RE: **Blythe Solar Power Project, Docket No. 09-AFC-6**
Responses to January 14, 2010 CEC Workshop Queries (Groundwater)
Technical Areas: Soil & Water Resources

**Responses to CEC Workshop,
January 14, 2010
Soil and Water Resources
(Groundwater)**

**Blythe Solar Power Project
Docket No. 09-AFC-6**

Groundwater Data Responses to January 14, 2010 CEC Workshop Queries – Blythe Solar Power Project

**Figure DR-S&W-179-1 (Rev. 1)
 Distribution of Runoff "Type"
 After Hely and Peck (1964)
 Palo Verde Meas
 Groundwater Basin**

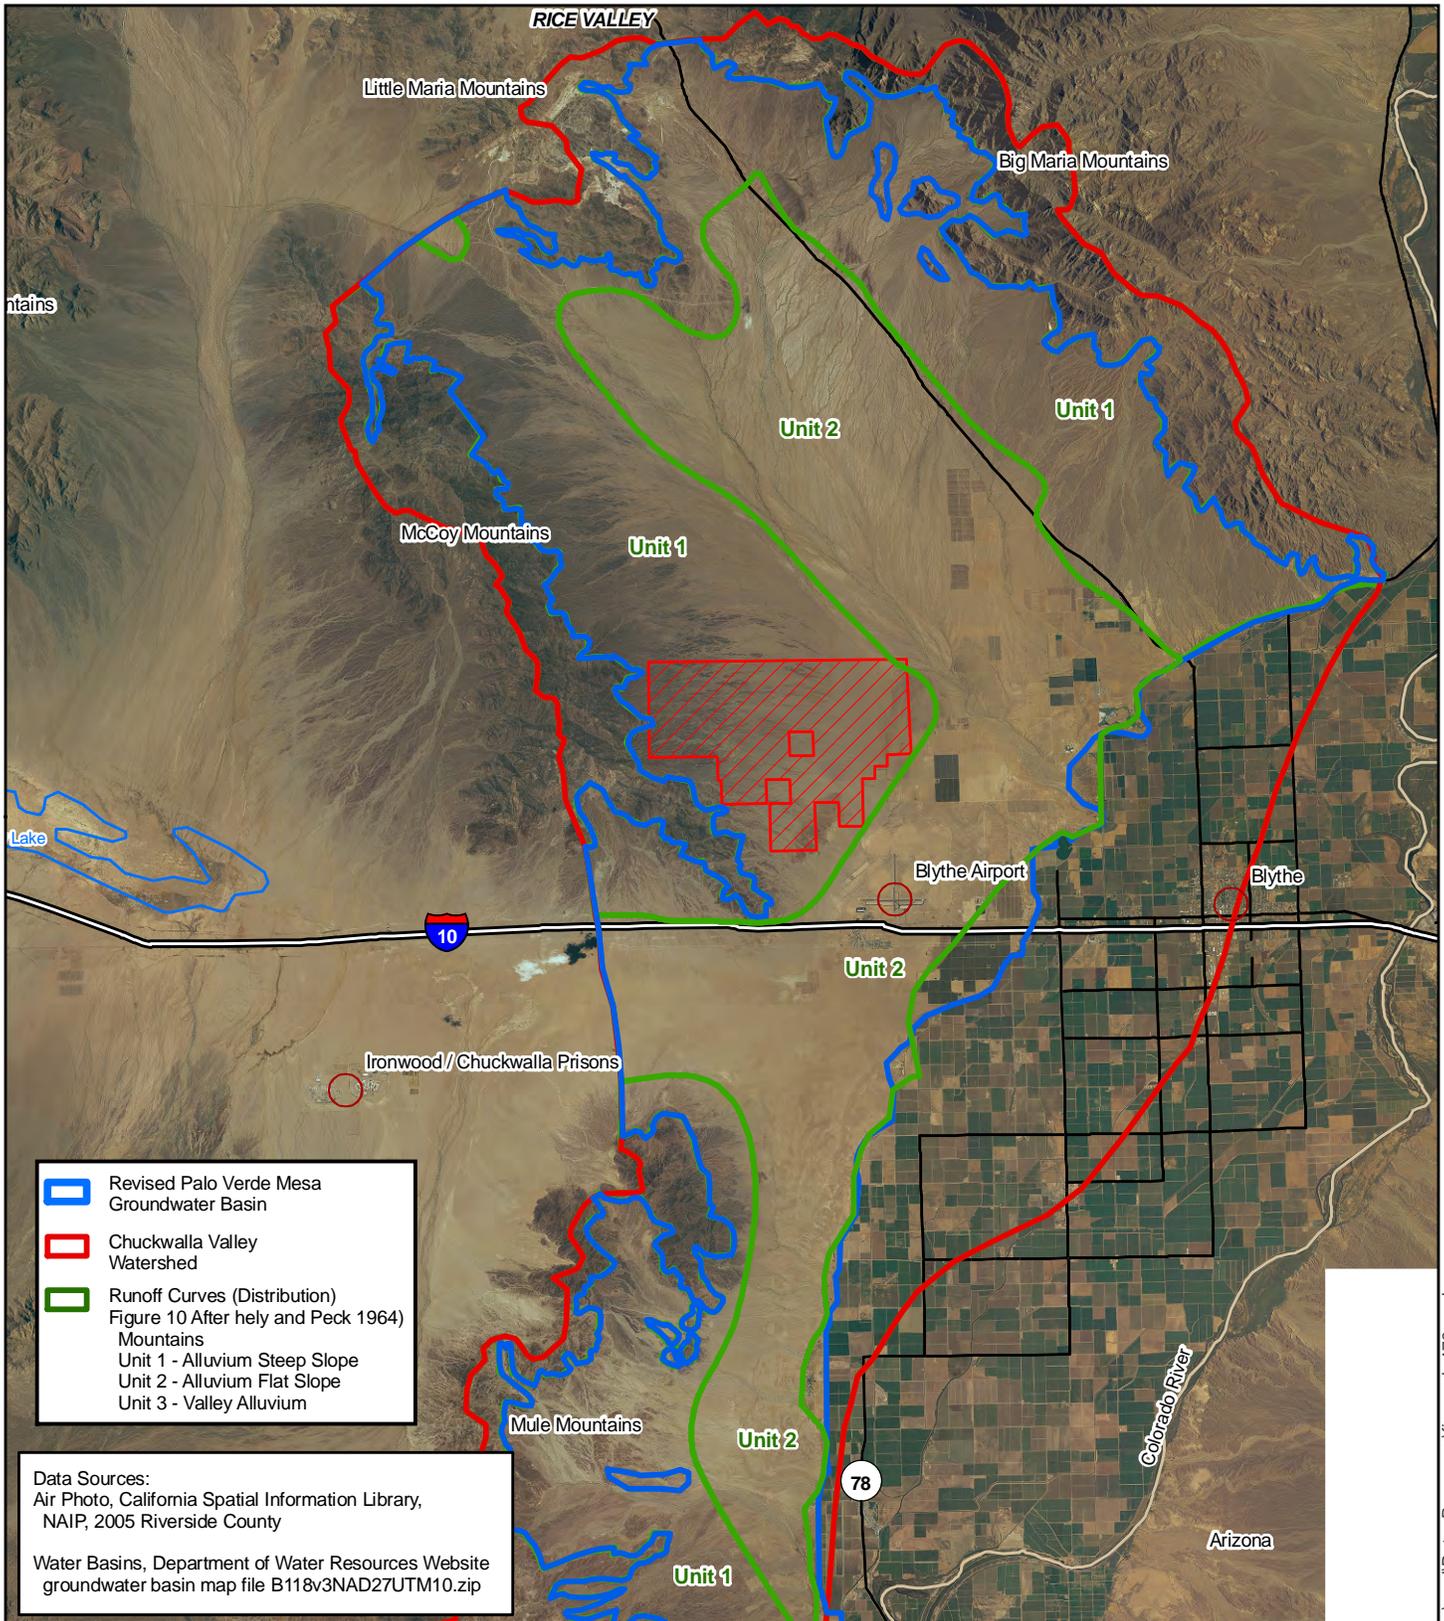
Update the runoff recharge estimates (DR-S&W-194) to reflect 2, 5, and 10% of total calculated runoff value. Use Basin inflow/outflow example from Genesis.

The revised PV Mesa boundary has an area of approximately 184,056 acres and is shown on Figure DR-S&W-179-1(rev1). The other significant changes to the water balance from what was provided in the January 6, 2010 response to DR-S&W-179 was the addition of agricultural recharge rates and the addition of discharge rates for municipal, private and agricultural uses on the PV Mesa.

In revising the infiltration estimate, the first step was to overlay the average annual isoheytal contours shown on Figure 6 from Hely and Peck (1964) onto the topography of the Basin, Figure DR-S&W-179-1(rev 1). The second step was to multiply the average annual precipitation within each contour times the area of the contour to derive an estimate of total precipitation in acre-feet for the Basin. Lastly, the total within each contour is multiplied by percentages of 3%, 5% and 10% representing an estimate of infiltration from precipitation within the contour and summing the individual areas to a total annual infiltration volume (acre-feet) for the Basin. Table DR-S&W-179-1(rev 1) presents the estimate of total annual infiltration for the Palo Verde Valley Groundwater Basin for these estimates of infiltration. The infiltration estimates range from 2,058 acre-feet (3%) to 10,288 acre-feet (10%).
